Posted: _____

Remove: _____

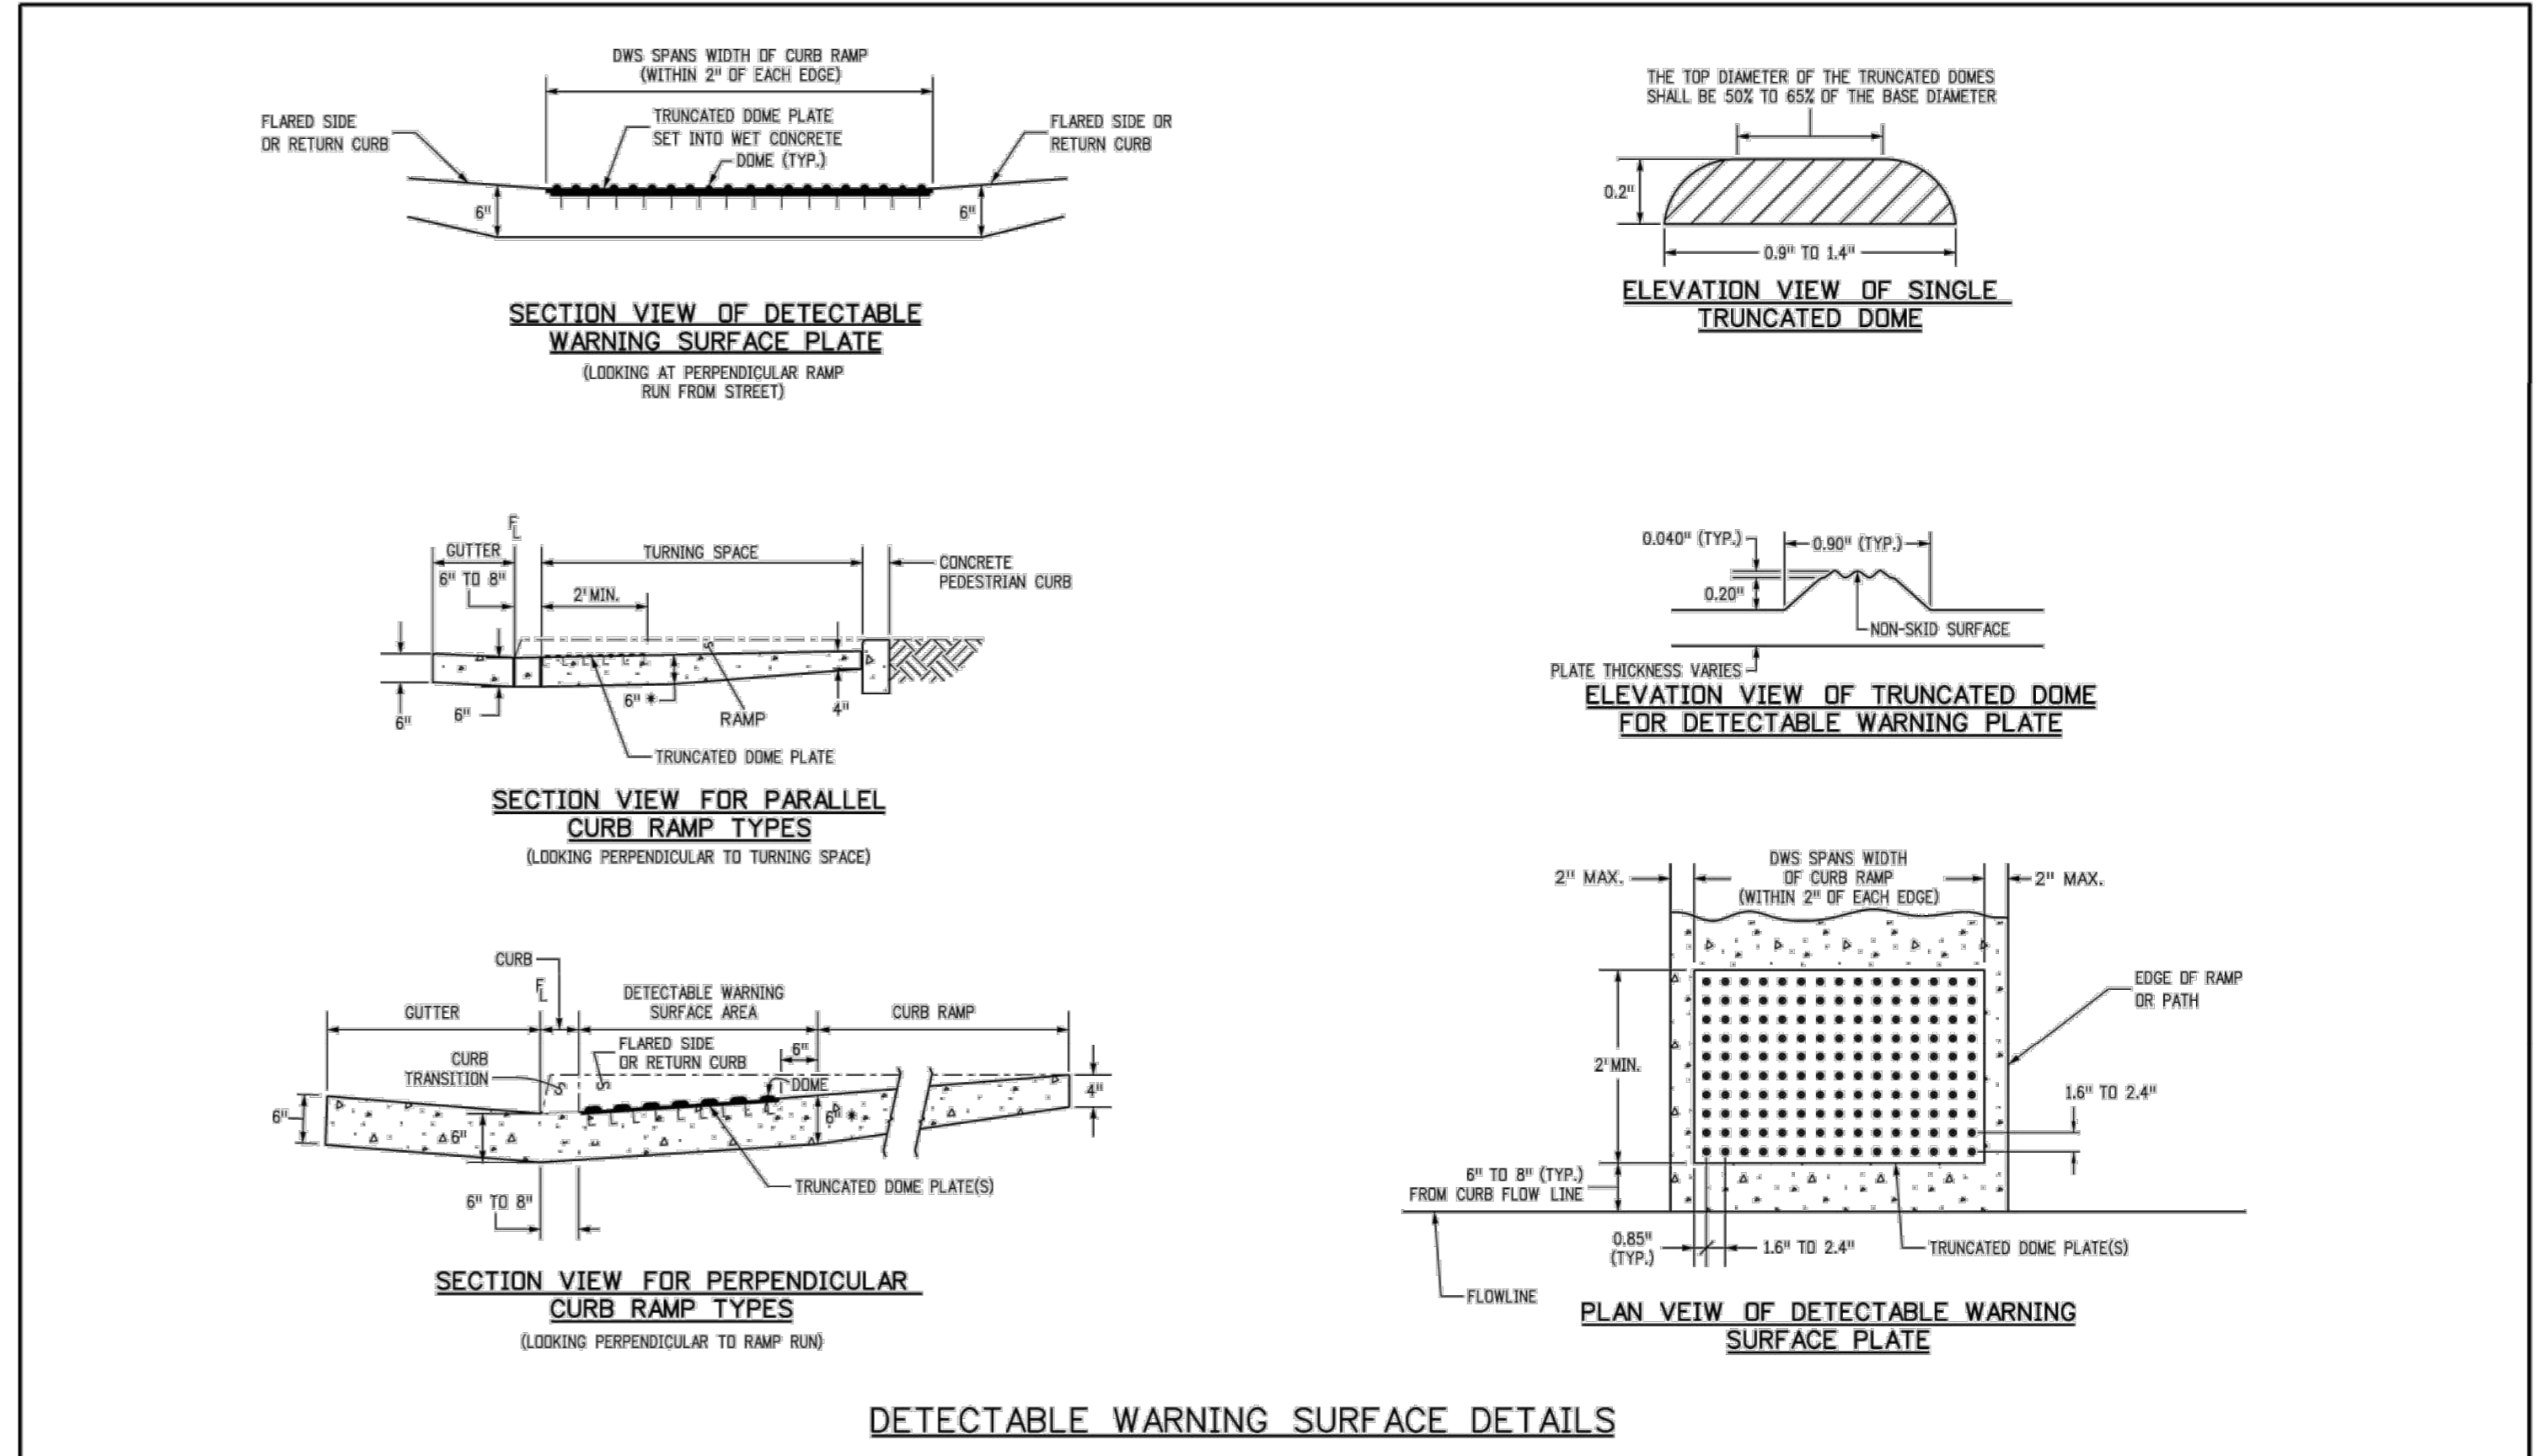
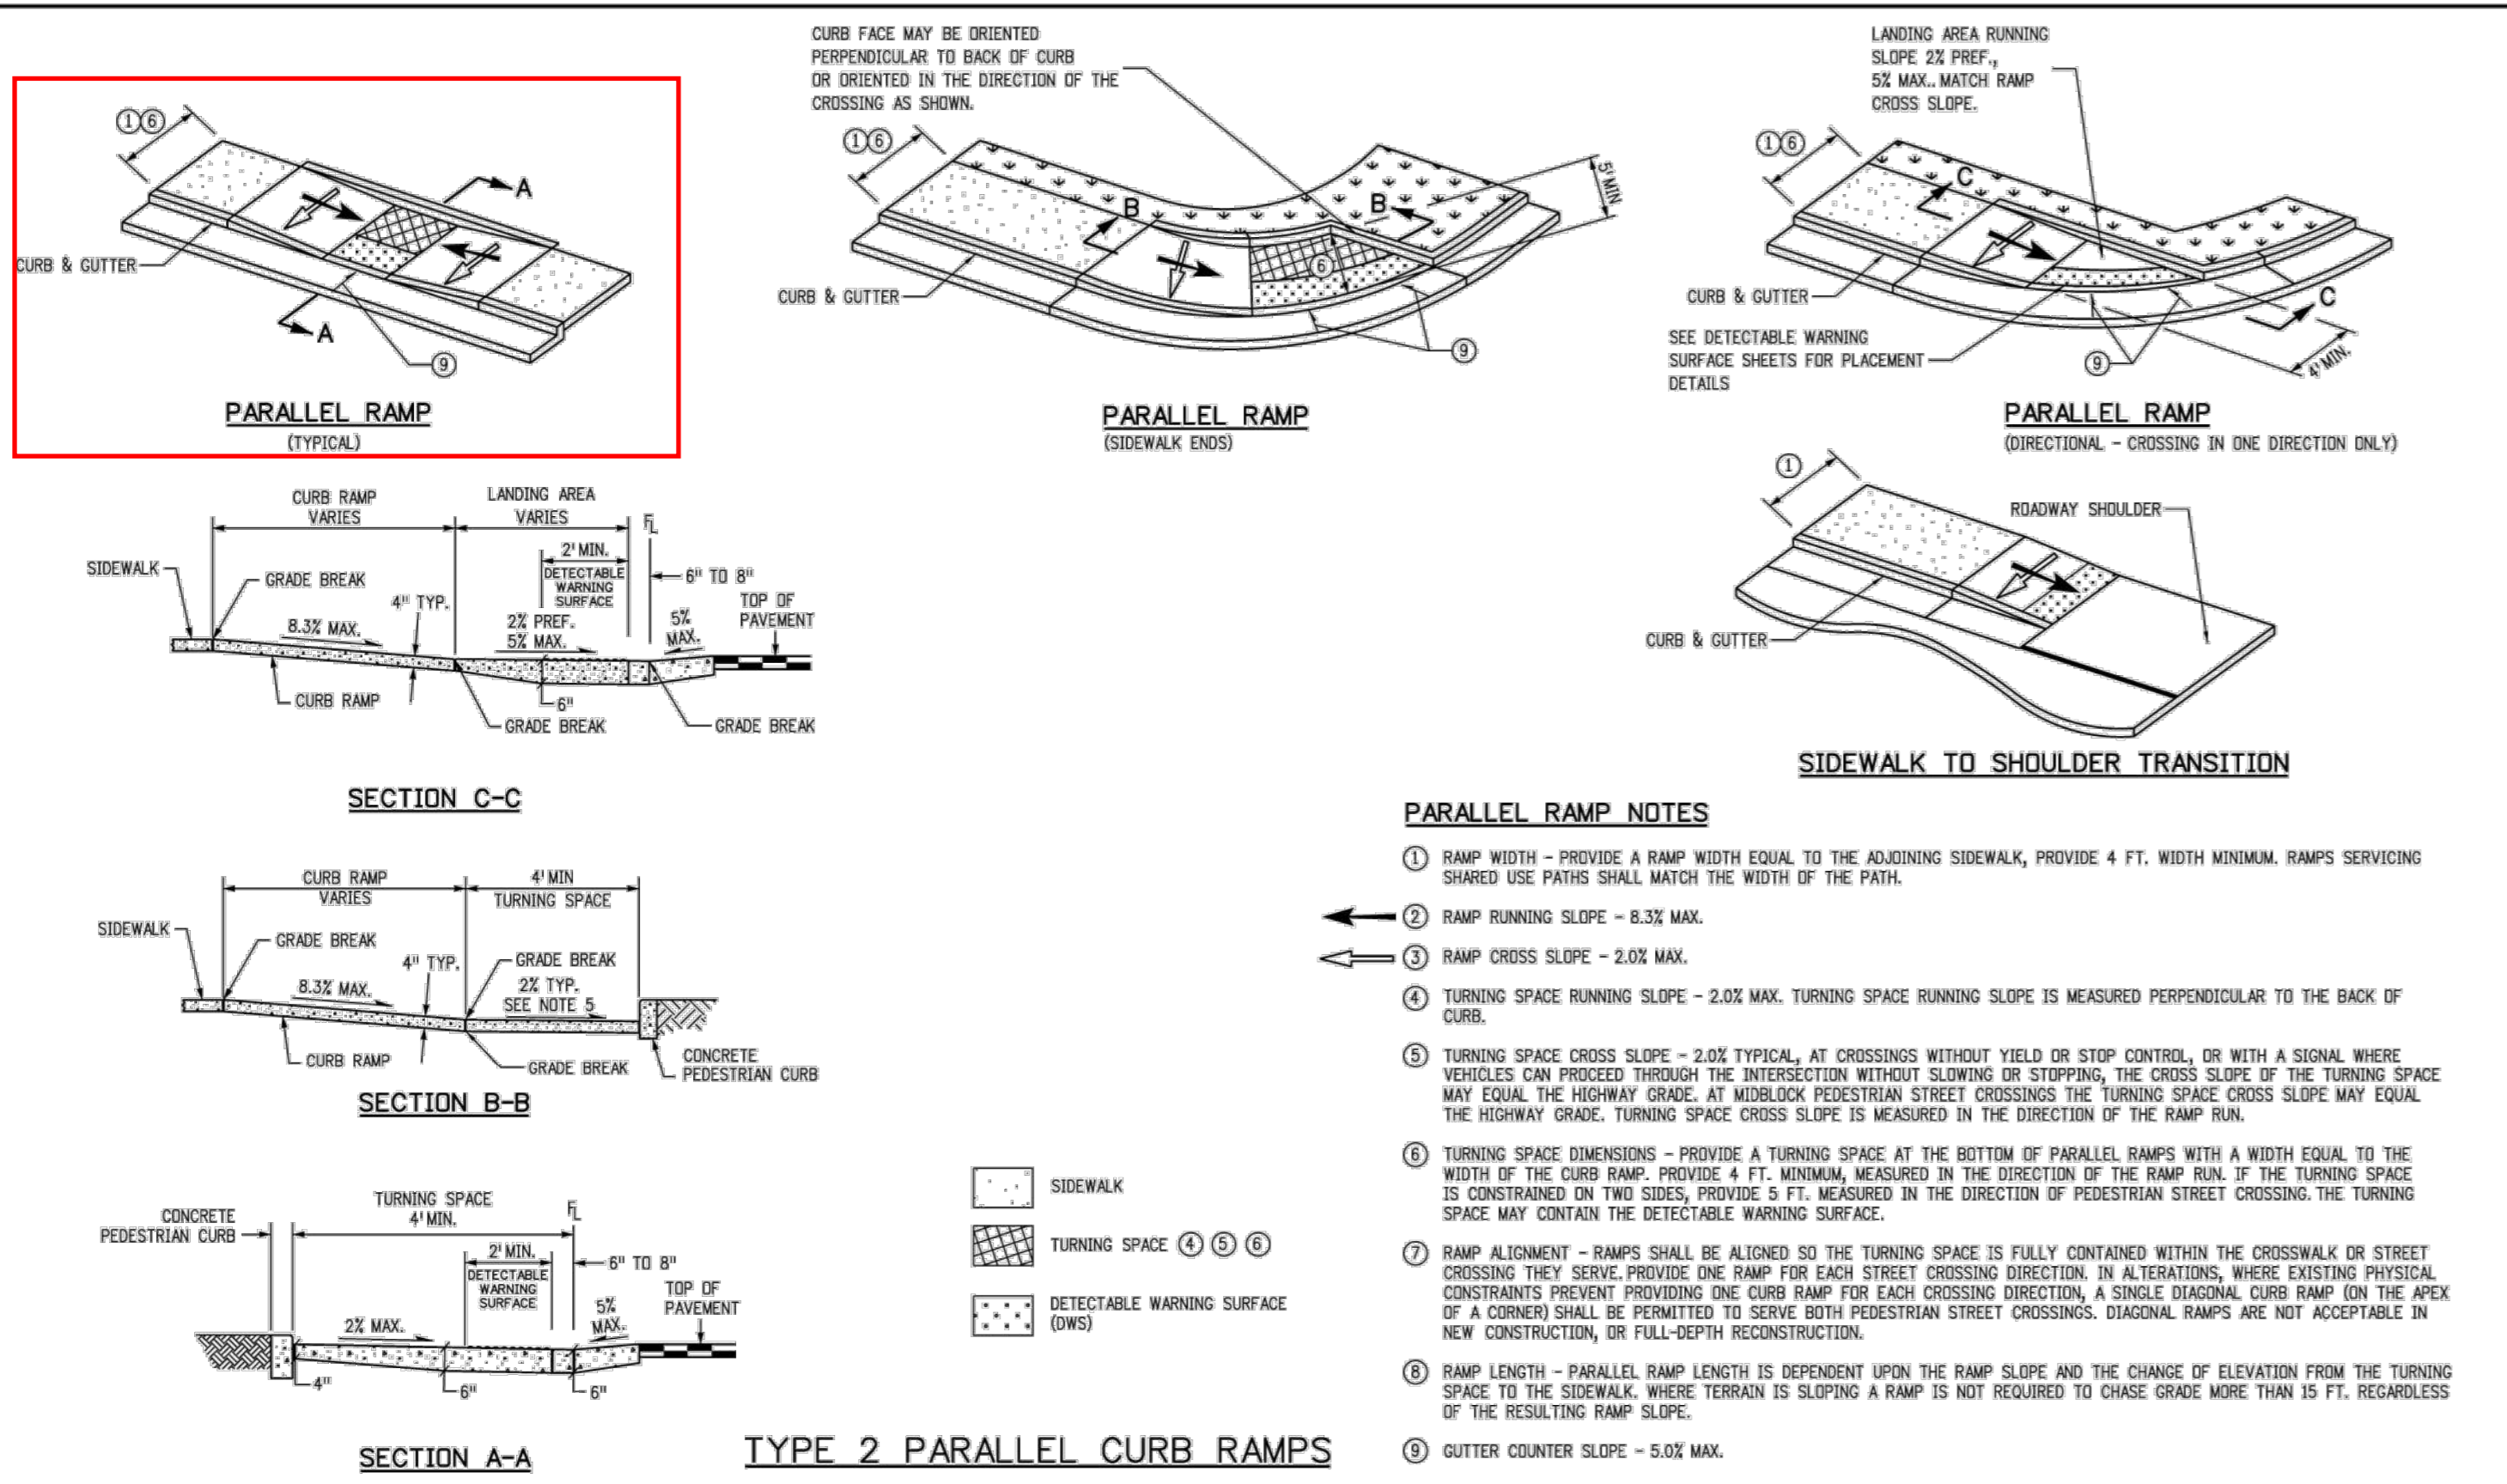
Computer File Information		Sheet Revisions		Colorado Department of Transportation		STANDARD PLAN NO.	
Creation Date: 07/31/19	Designer Initials: JBK	Date:	Comments:	2829 West Howard Place C2011 HQ, 3rd Floor Denver, CO 80204 Phone: 303-757-9021 FAX: 303-757-9868		M-608-1	
Last Modification Date: 07/31/19	Detailer Initials: LTA			Project Development Branch		Standard Sheet No. 4 of 10	
CAD Ver: MicroStation V8 Scale: Not to Scale Units: English				Project Development Branch		Project Sheet Number:

Computer File Information		Sheet Revisions		Colorado Department of Transportation		STANDARD PLAN NO.	
Creation Date: 07/31/19	Designer Initials: JBK	Date:	Comments:	2829 West Howard Place C2011 HQ, 3rd Floor Denver, CO 80204 Phone: 303-757-9021 FAX: 303-757-9868		M-608-1	
Last Modification Date: 07/31/19	Detailer Initials: LTA			Project Development Branch		Standard Sheet No. 10 of 10	
CAD Ver: MicroStation V8 Scale: Not to Scale Units: English				Project Development Branch		Project Sheet Number:
